Service Bulletin

Subject: REAR DOOR WILL NOT OPEN	Bulletin No: 09-023/13
	Last Issued: 08/13/2013

APPLICABLE MODEL(S)/VINS

2014 Mazda6 vehicles with VINs lower than JM1 GJ ***** 119979 (produced before April 9, 2013)

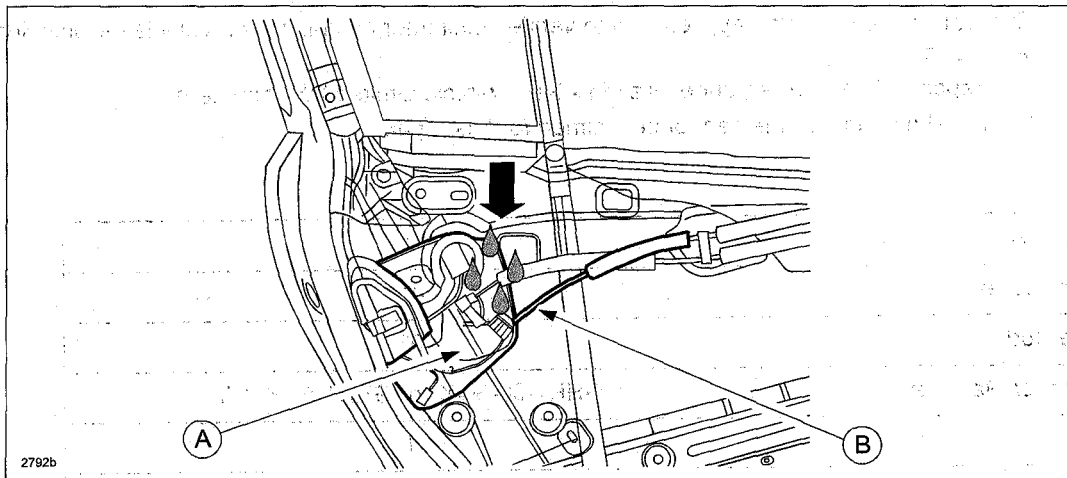
When the ambient temperature drops below 32 degrees Fahrenheit (0 degrees Celsius), especially after rain or car wash, some customers may experience a rear door(s) that will not open. This may be caused by water entering the inside of the rear door latch and lock actuator (A) and then freezing at low temperatures.

Customers having this concern should have their vehicle repaired using the following repair procedure.

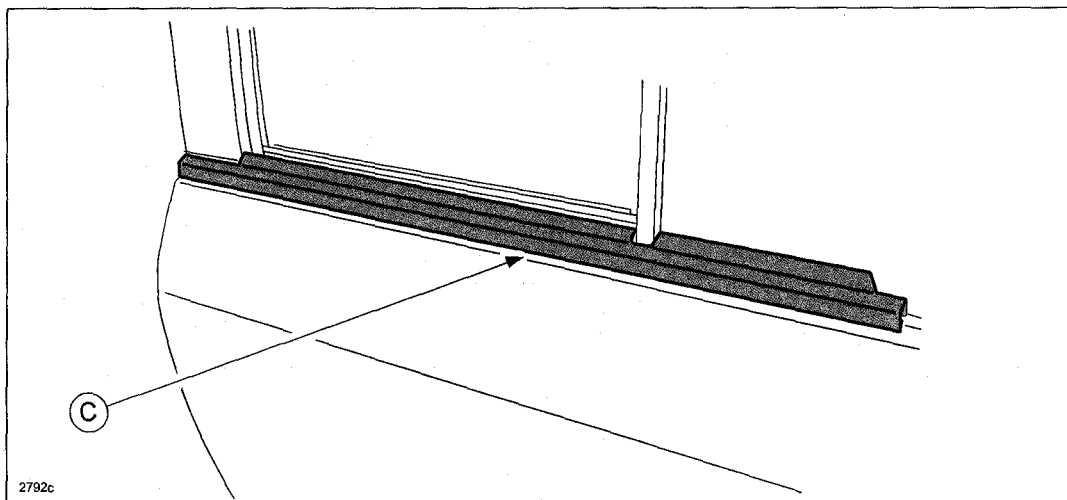
1. Verify customer concern.
2. Remove the rear door trim. Refer to MS3 online or Workshop Manual (section 09-17 REAR DOOR TRIM REMOVAL/INSTALLATION).
3. Remove service hole cover No.1. Refer to MS3 online or Workshop Manual (section 09-14 REAR DOOR LATCH AND LOCK ACTUATOR REMOVAL/INSTALLATION).
4. If wet, dry the rear door latch and lock actuator (A) and/or the door lock knob cable (B) using compressed air.

5. Replace the rear beltline molding (C). Refer to MS3 online or Workshop Manual (section 09-16 REAR BELTLINE MOLDING REMOVAL/INSTALLATION).

6. Install in the reverse order of removal.
7. Verify repair.
